SERVICE BULLETIN

No. 419

Piper Aircraft Corporation

Subject: Inspection of Elevator Control Tube Attachment

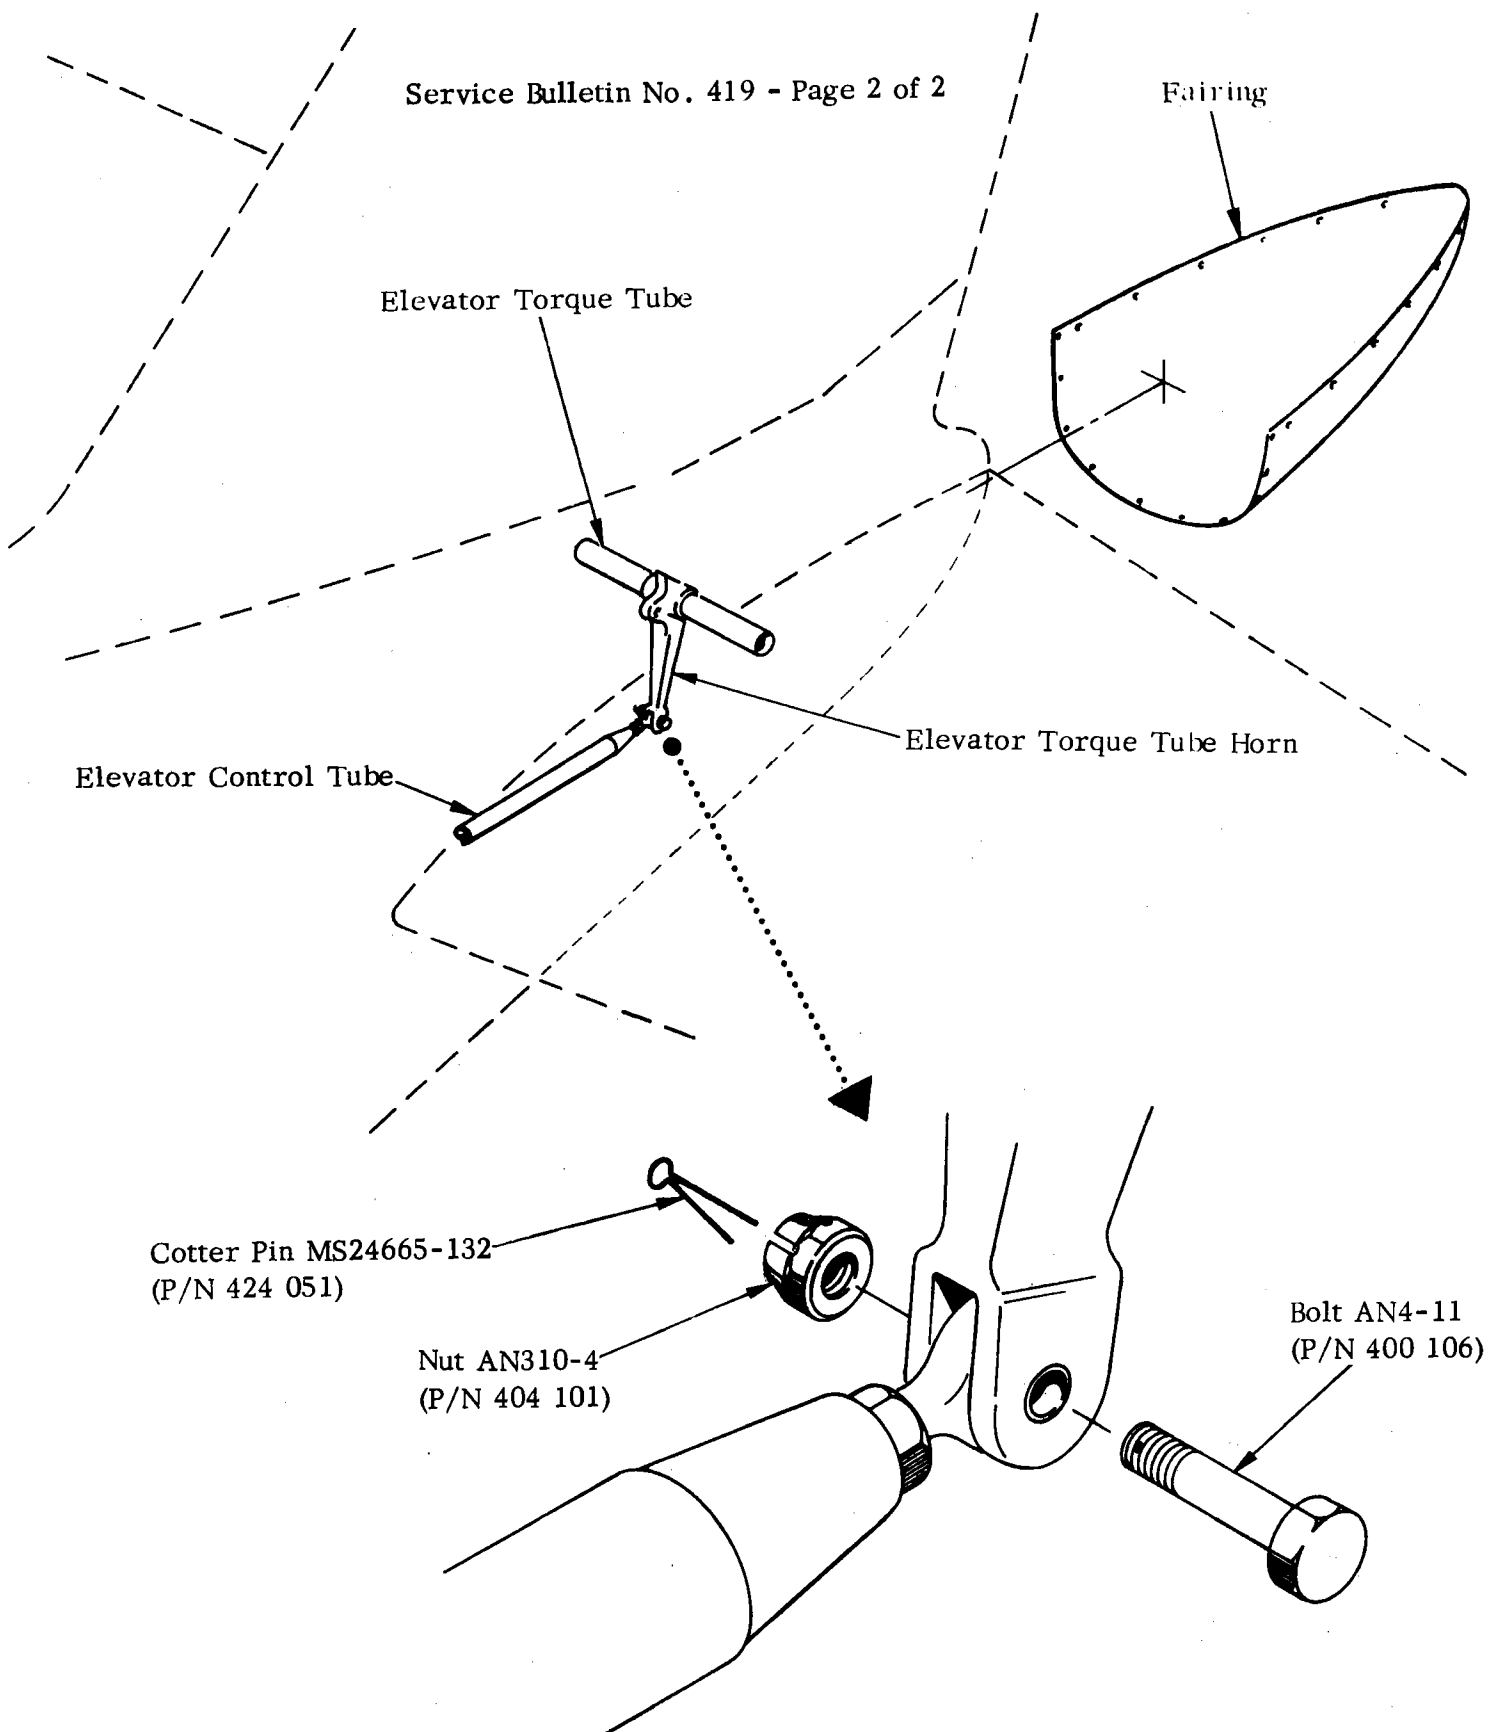
Purpose: To provide instructions to inspect the above referenced aircraft (subject to the provisions of Compliance Time, above) in accordance with the sketch/instruction data on the reverse side of this bulletin to insure proper installation of the elevator control tube assembly to the elevator torque tube horn -- refer to sketch on reverse side for an illustration of the affected area.

1. Remove lower half of fuselage tail fairing to gain access to the elevator torque tube horn.
2. Inspect elevator control tube attachment at torque tube horn to ensure that the bolt, nut and cotter pin are properly installed.
3. Make corrections, if required and reinstall tail fairing.
